Access Compliance Report Public Rights-of-Way (Curb Ramps)

Main Street: DAWNWOOD Cross Street: MAYBECK_LN Location: NW

ADA ID: RPRK211025115907 Ramp Type: Type 4 - Parallel Initial Pass/Fail: Pass Overall Compliance: No Severity Score: 25

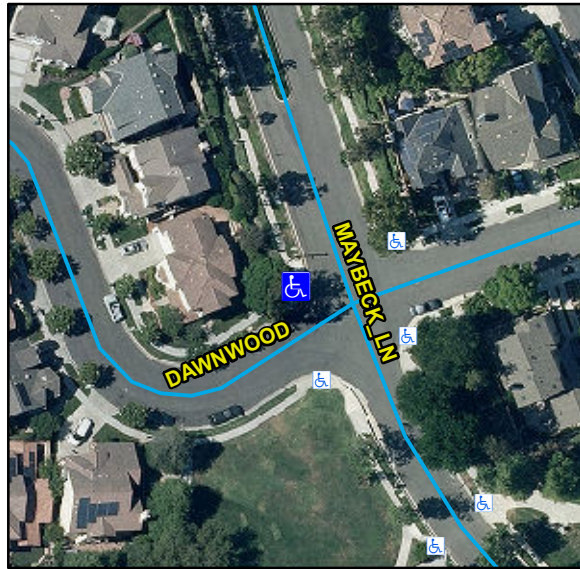
Compliance	Description	Data	Compliance	Description	Data
N/A	Ramp Length LT (in)	114	N/A	Ramp Length RT (in)	105
Yes	Ramp Width LT (in)	53	Yes	Ramp Width RT (in)	53
Yes	Ramp Run Slope LT (%)	7.9	Yes	Ramp Run Slope RT (%)	3.8
Yes	Ramp Cross Slope LT (%)	0.6	Yes	Ramp Cross Slope RT (%)	0.7
N/A	Landing Present	No	No	DWS Provided	No
N/A	Landing Length (in)	N/A	N/A	DWS Contrast	N/A
No	Landing Width (in)	N/A	N/A	DWS Length (in)	N/A
No	Landing Run Slope (%)	N/A	N/A	DWS Full Width	N/A
No	Landing Cross Slope (%)	N/A		DWS Offset Type	N/A
N/A	Landing Movement Obstructed?	No	N/A	DWS Offset Left (in)	N/A
	Landing Movement Type	Curb	N/A	DWS Offset Right (in)	N/A
N/A	Landing Shared	N/A			
N/A	Clear Space	Yes			
N/A	Clear Space To Crosswalk (in)	48			
N/A	Marked Crosswalk 1	No	N/A	Marked Crosswalk 2	No
	Crossing 1 Direction	S		Crossing 2 Direction	E
	Marked Crosswalk 1 Width (in)	N/A		Marked Crosswalk 2 Width (in)	N/A
N/A	Ramp Inside Crosswalk 1	N/A	N/A	Ramp Inside Crosswalk 2	N/A

Crossing 1 Slope (%)	4.3		Crossing 2 Slope (%)	2.5
	Crossing 1 Cross Slope (%)	2		Crossing 2 Cross Slope (%)	4.2
Yes	Gutter Ponding	No	Yes	Curb Slope	6.5
Yes	Gutter Lip Height (in)	0		Road Run Slope (%)	2.9
No	Gutter Run Slope (%)	5.8		Road Cross Slope (%)	2.9
Yes	Gutter Cross Slope (%)	1.8	No	Perpendicular Joint Present	No
Yes	Overall Surface Condition	Acceptable			
	Cross Gutter Present?	No		Spandrel Present?	No
	Replace Cross Gutter?	N/A		Replace Spandrel?	N/A

Remove & Replace Curb Ramp With Two New Directional Ramps or Equivalent. Remove & Replace Gutter.
